Old Arcata Road Design Project Kick-off Meeting – Community Input Received

Held September 12, 2016 at the Bayside Grange

Above: Photo of poster with sticky dot votes

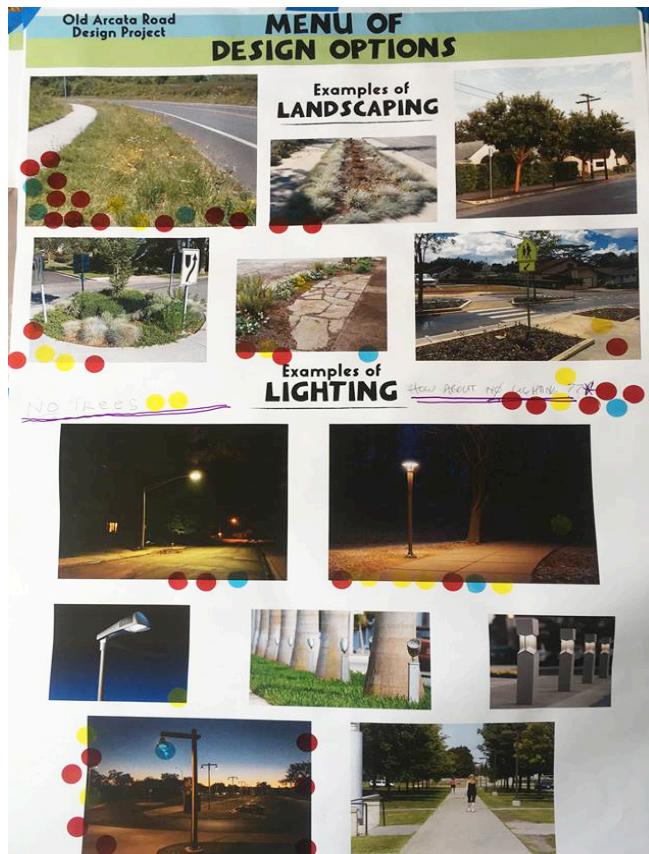
- Landscaping: strong preference for low-growing grasses, flowers and small shrubs
- Lighting: preference for downcast, pedestrian-scale lighting with simple modern look, as well as a written comment for “no lighting” that received many stickers, as well.
